DATE: August 15, 2023

RE: CEQA 15164 Determination for Proposed Post-Fire and Odor Management Engineering Design/Project Description Changes (PD Change No. 5): Finding that Section 15164 of the State CEQA Guidelines applies to minor changes to the ReSource Center at the Tajiguas Landfill. CEQA Guidelines Section 15164 allows an Addendum to be prepared when only minor technical changes or changes that do not create new significant impacts would result. The Final Subsequent EIR (SEIR)(12EIR-00000-00002, SCH #2012041068) and the SEIR Revision Letter and Errata dated May 27, 2016 and SEIR Addendum dated August 11, 2017 (revised October 26, 2017), 15162 determinations dated January 15, 2020, May 18, 2020, and August 2, 2021 are hereby amended by this Addendum.

Location: The project is located at the Tajiguas Landfill on Assessor's Parcel Numbers (APN) 081-150-042, 081-150-019 and 081-150-026, located approximately 26 miles west of the City of Santa Barbara, along the Gaviota coast, Third Supervisorial District.

S:\Work\Projects\Tajiguas\Drawings\2022 New Projects\Exh3 - MRF Biofilter Replacement with Vent Stacks.dwg 11/8/2022 2:05 PM

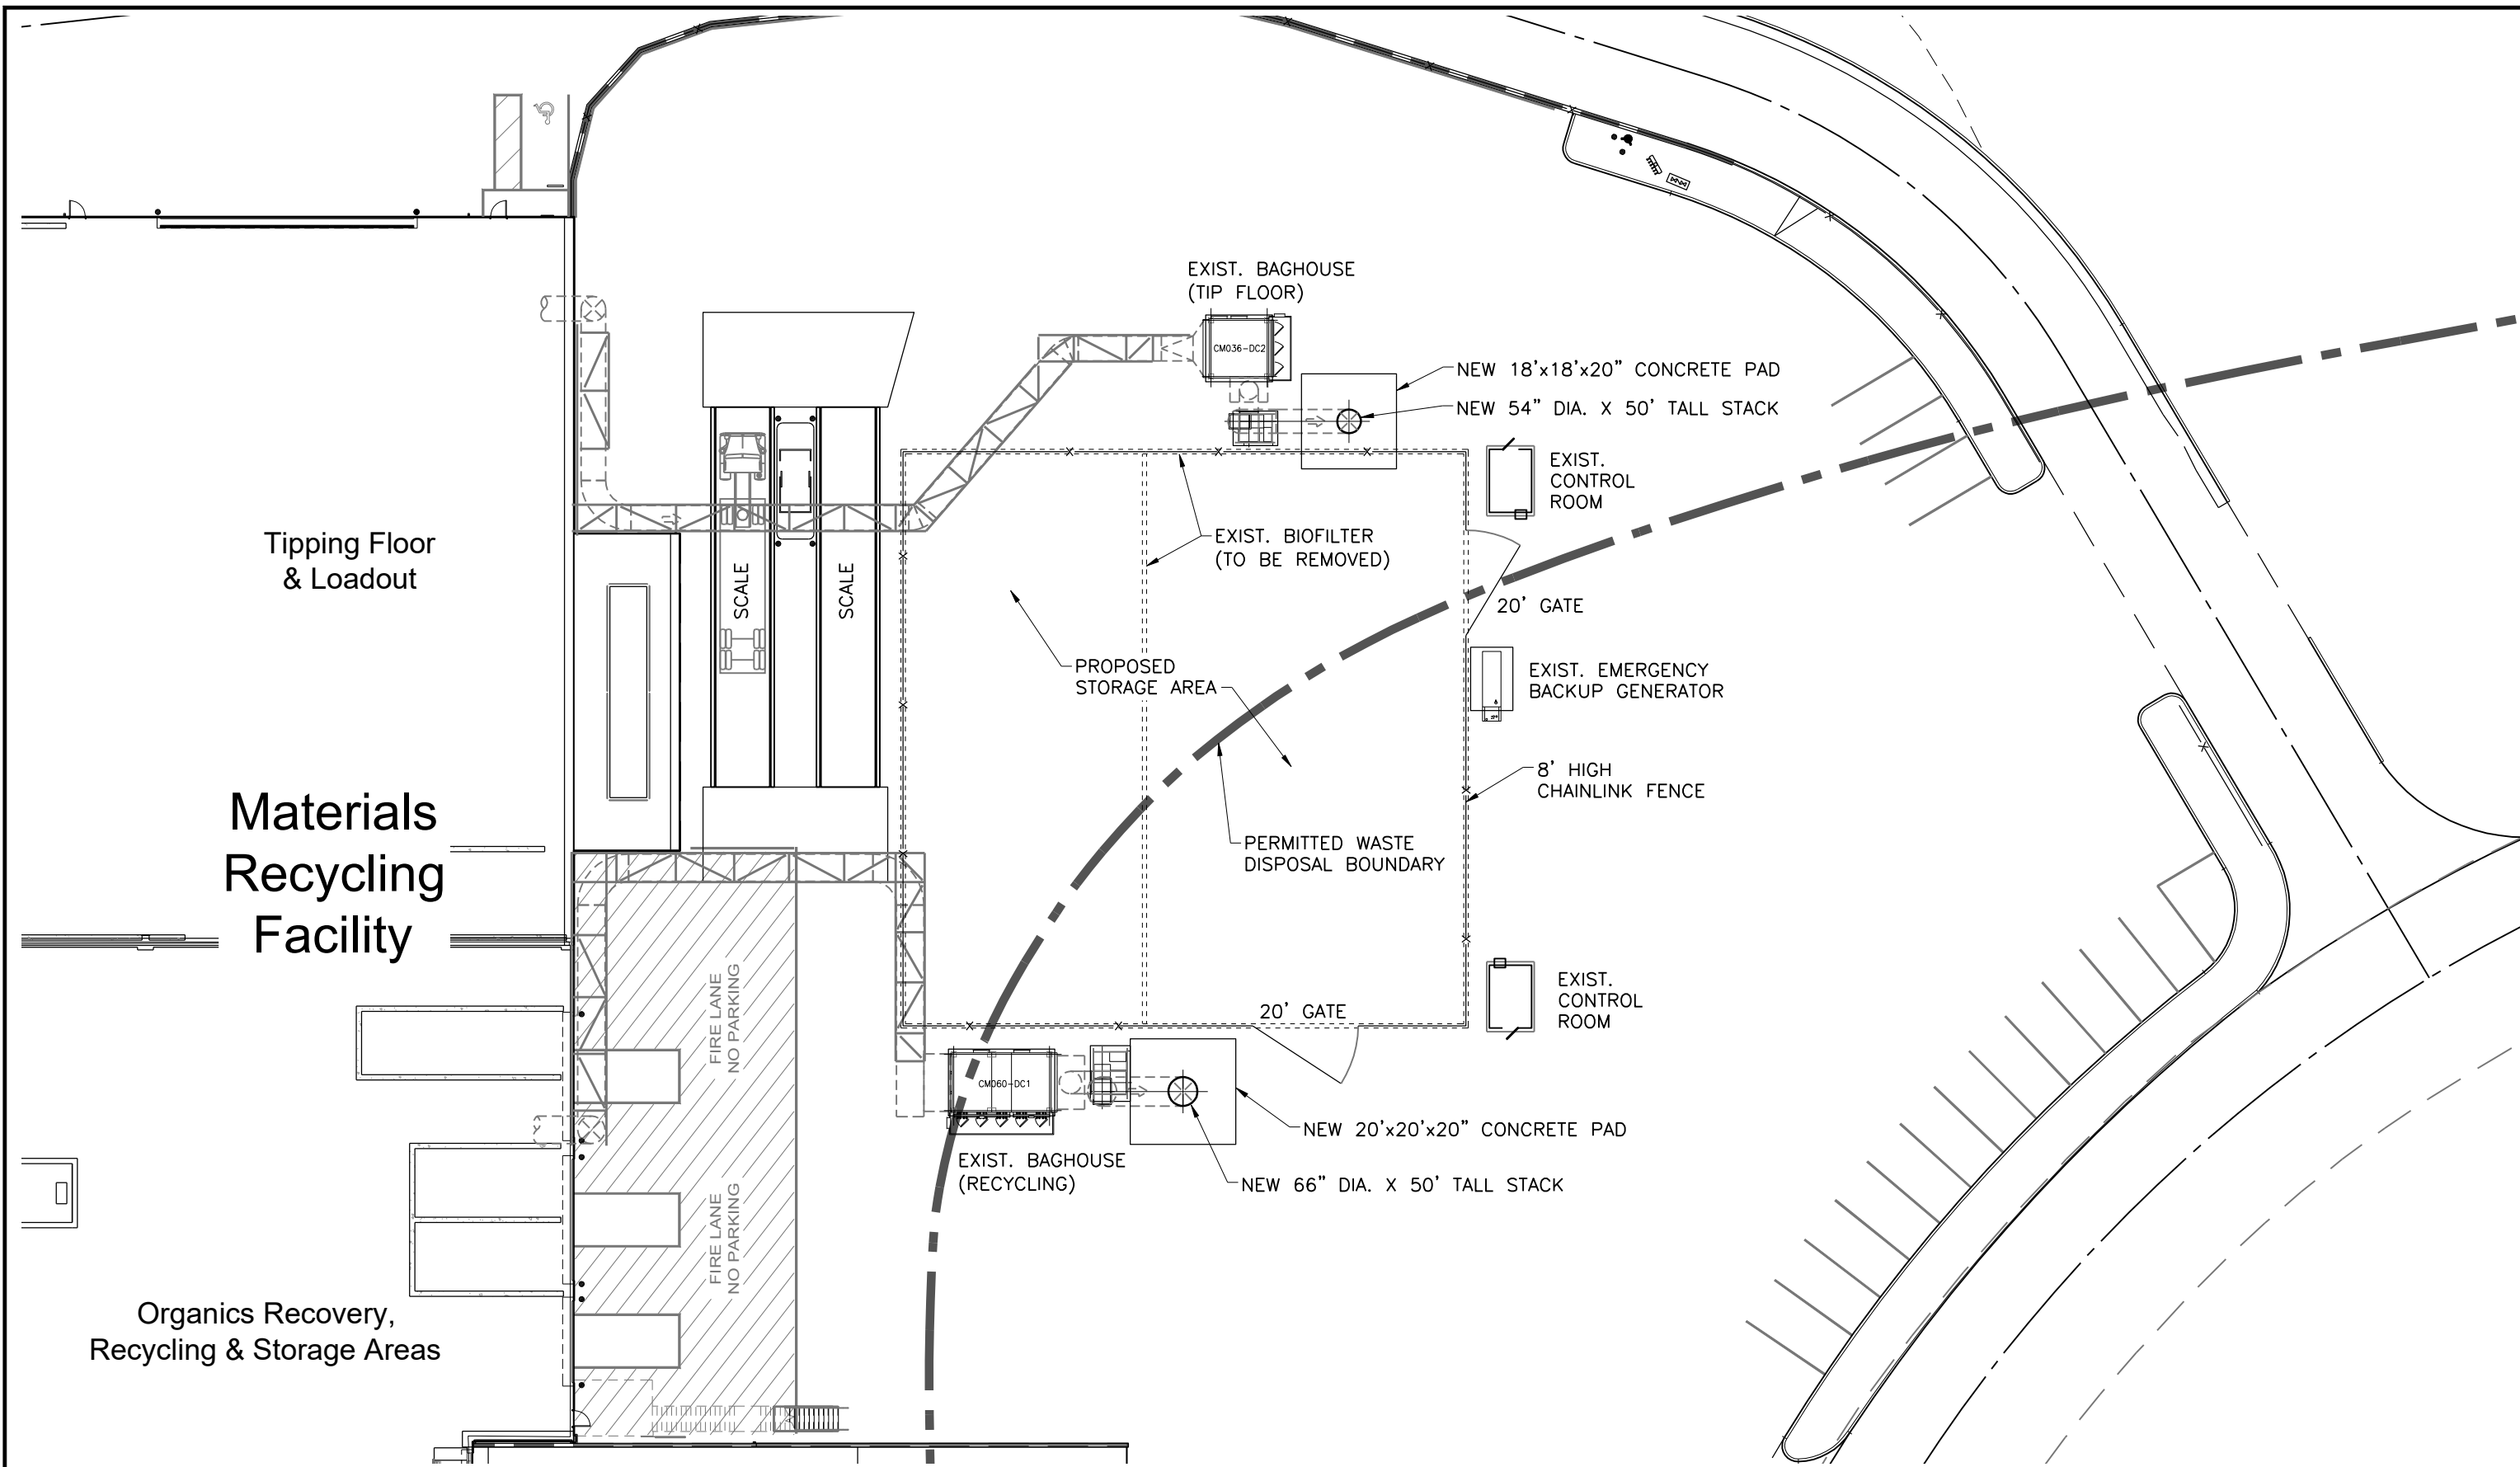
Demolish the Remaining Components of the Alisal Fire Impacted MRF Biofilters and Replace with Direct Venting of CMAXX Baghouse Filters to Two (2) New 50-Foot-Tall Vent Stacks and Construct New Fenced Recyclable Storage Area. Installation of a MRF biofilter system was a part of the original ReSource Center project description to treat odors and reduce PM emissions along with a misting system within the MRF building (12EIR-00000-00002, Sections 3.5.1.1. and 3.5.9.3). As noted above the biofilter system was significantly damaged by the Alisal Fire and will not be replaced. The CMAXX baghouse PM filter and exhaust system will be replaced including new vent stacks.

The proposed vent stacks will disperse the MRF building air collected and treated by the baghouse filters. Both stacks will be approximately 50-feet in height above existing grade. One new 54-inch diameter stack will be erected at the north end of the existing biofilter area. One new 66-inch diameter stack will be erected at the south end of the biofilter area. The two proposed vent stacks are required to be 50-feet in height to allow them to be higher than the adjacent buildings in order to provide the air dispersion necessary to meet air quality standards. In addition, because the MRF building air will not need to be brought to ground level for treatment in the biofilters, the stacks minimize energy use required for the system. The existing exhaust conduits exit the MRF building at a height of 36 feet. Without the biofilters, there is no longer a need to bring the exhaust down to ground level for treatment and dispersal. The air exhausted from the MRF building is the highest temperature air from within the MRF building, near the ceiling level. Less energy is consumed by the fans if the air within the MRF is discharged above the point where the exhaust conduit leaves the building.

New duct work and fans will be installed connecting the two baghouses to their respective vent stacks. The footings for the two vent stacks will be located above the waste footprint constructed on the existing asphalt and concrete pad for the MRF. Pursuant to recommendations provided by consulting geotechnical engineers (Earth Systems, 2022), the footings will not be constructed near any slope that would warrant a slope stability analysis to be performed. The vent stack footings will be supported on a minimum of 3-feet of compacted engineered fill to ensure all seismic and structural requirements are met.

Exhibit 4
CMU Irrigation and Dust Control Misting System

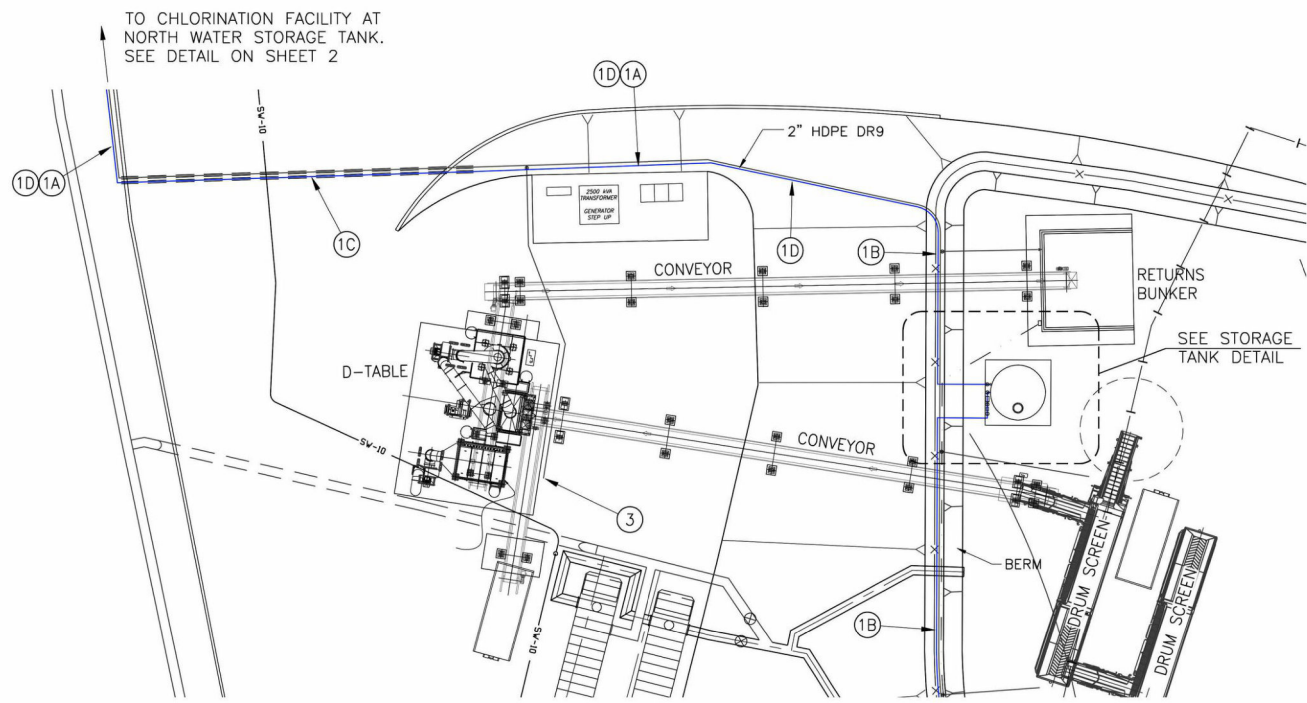
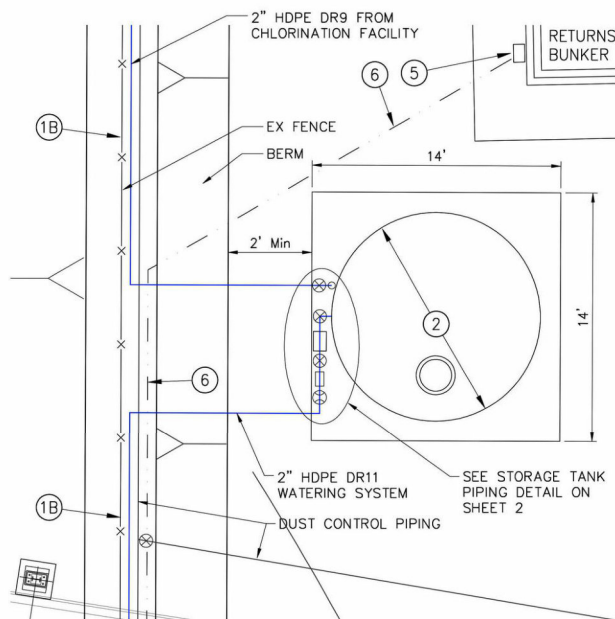
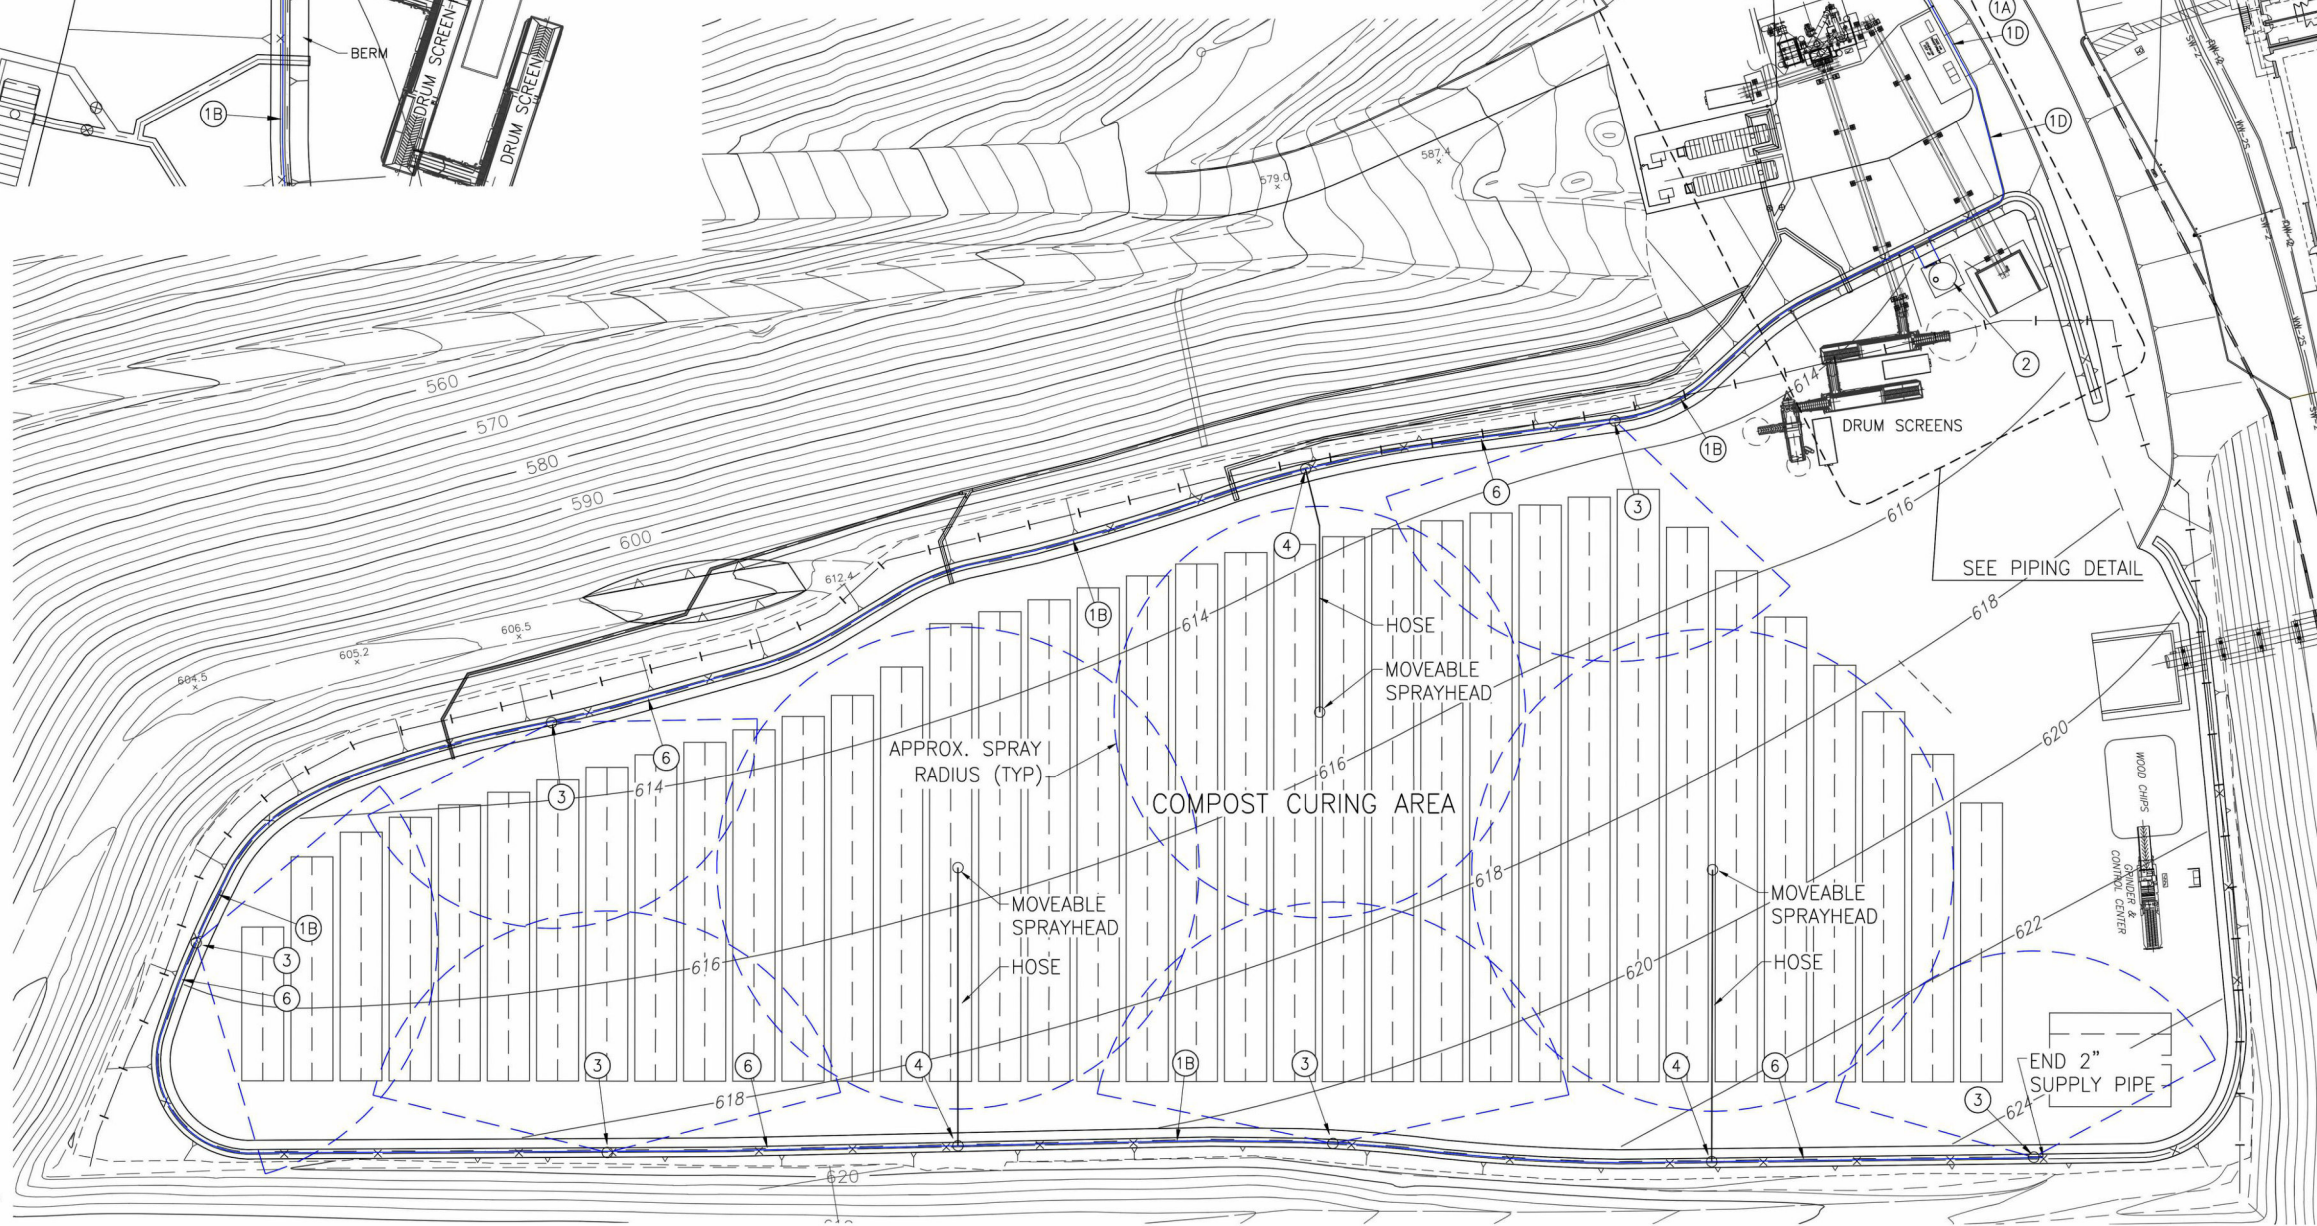
The proposed compost irrigation system, which includes a new sprinkler system, is capable of providing up to 40 gallons/minute (gpm) to any location within the compost curing area (see Exhibit 4) at the CMU. The new compost irrigation system will have a control panel which is capable of setting customized flow durations for each sprinkler head so that the operator can apply more water to a particular windrow, as needed (see Exhibits 5 and 6). The existing windrow turner will turn each pile after the sprinkler for that row has stopped. A new 15,500-gallon water storage tank and electric booster pump is required for the new sprinkler system. No new water treatment facilities are required for the new sprinkler system.
